Subject: Additional Information concerning the operation of Dresden Unit 2

SUPPLEMENTARY INFORMATION
for
DRESDEN UNIT 2
SPECIAL REPORT NOS. 8 AND 11

SUPPLEMENTARY INFORMATION
for
DRESDEN UNIT 2
SPECIAL REPORT NO. 13

SUPPLEMENTARY INFORMATION
for
DRESDEN UNIT 2
SPECIAL REPORT NOS. 2 AND 7

FIGURE 4

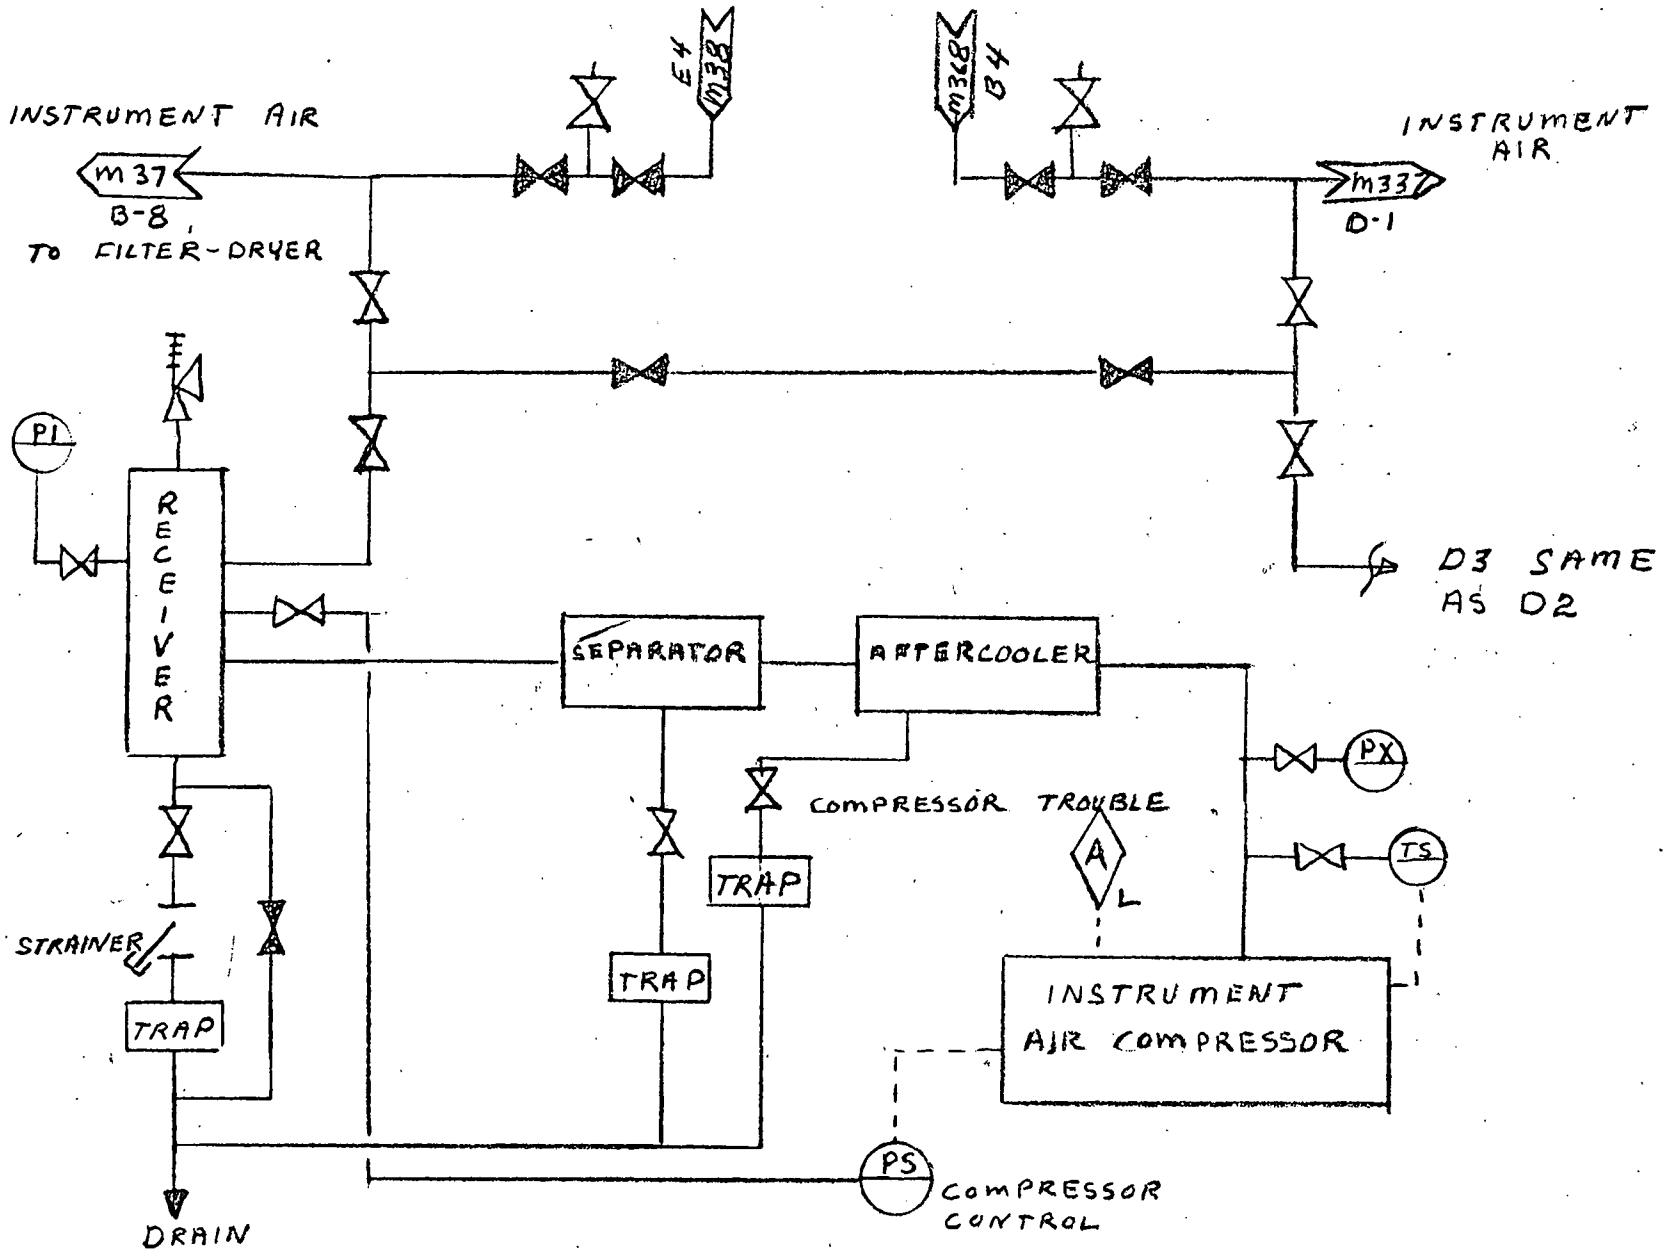
- II. Provide description of the interim and final design for the instrument air supply for the outside main steamline isolation valves.

Final action will consist of complete separation of the Instrument Air System from the existing Station Air Compressor System. Thus leaving the existing station air compressors serving only the station service air requirements. All of the existing instrument air piping and tubing will be thoroughly cleaned with an appropriate cleaning agent, flushed, and blown clear. Where this is not practical, the pipe and/or tubing will be replaced. Two new air-compressors each having a capacity of 216 acfm at a nominal system pressure of 110 psig are being provided to serve the Station Instrument Air Supply needs exclusive of the Primary Containment. Existing pre-filters, dryers, and after-filters will be utilized to assure instrument quality air. A simplified schematic diagram of the system is shown on Figure 4.

Each instrument air compressor shall be installed so that it normally supplies one plant only. Plant operation will be such that if one compressor fails or is shut down for servicing, the remaining compressor will service both plants. Each instrument air system alarms in the control room on low receiver pressure or shutdown of the compressor.

FIGURE 1

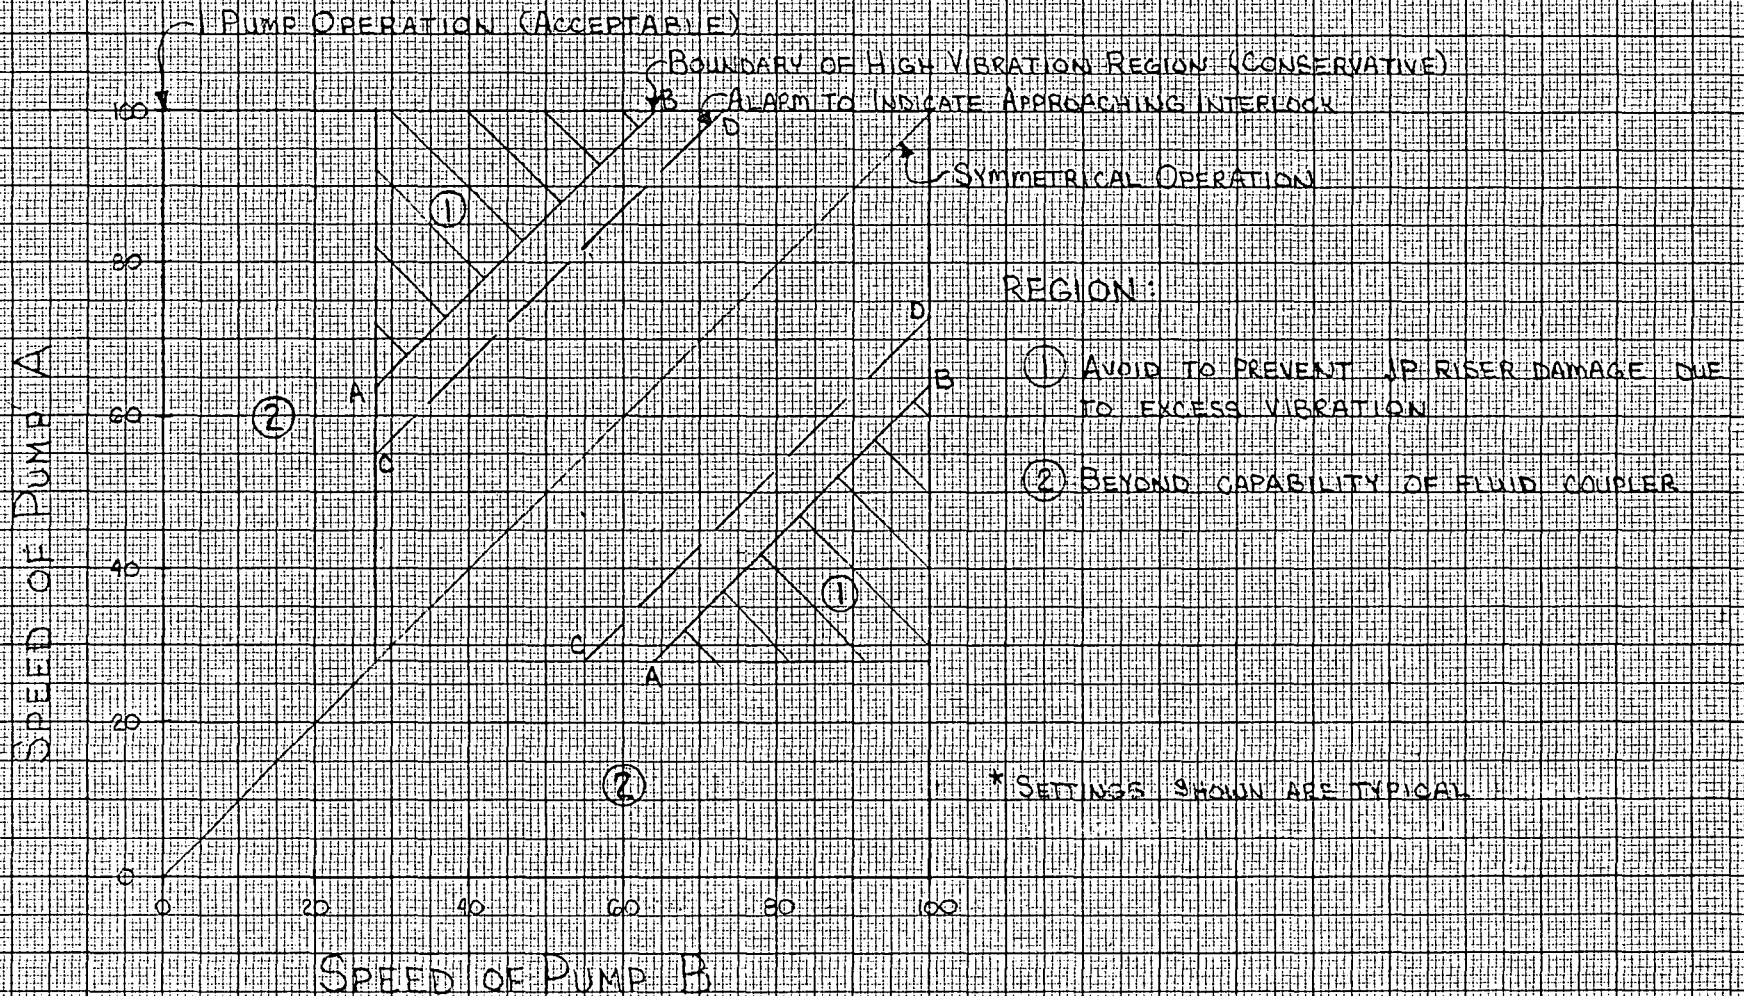
Provide a curve to show the relationship of recirculation pump speed and area where high vibrations occur. Also provide information concerning the procedures which have been established to prevent operation in an area which results in vibrations in relation to power level

A high "speed asymmetry" between the two recirculation pump causes opposition of flows in the low speed loop jet pumps and consequent vibration of the jet pumps and their riser braces. A curve showing the relationship of pump speed to the set points of the alarm and interlock is shown on Figure 1. The area of prohibited operation has been conservatively defined and is shown as region 1 on Figure 1. The interlock system is being designed to perform the following functions:

1. Automatically prevent restarting an idle recirculation pump when the operating pump exceeds 65% of design speed. An alarm in the control room will be activated if the speed of the active pump is greater than 65% and a restart of the idle pump is attempted.

2. Prevent recirculation pump operation from shifting into region 1 of Figure 1 by providing limiters set to function along lines AB of Figure 1. This interlock will not prevent any normal pump trips from occurring.
3. Provide an alarm in the control room which will be actuated when recirculation pump operation falls within 5% of region 1 of Figure 1 as shown by lines CD of Figure 1.
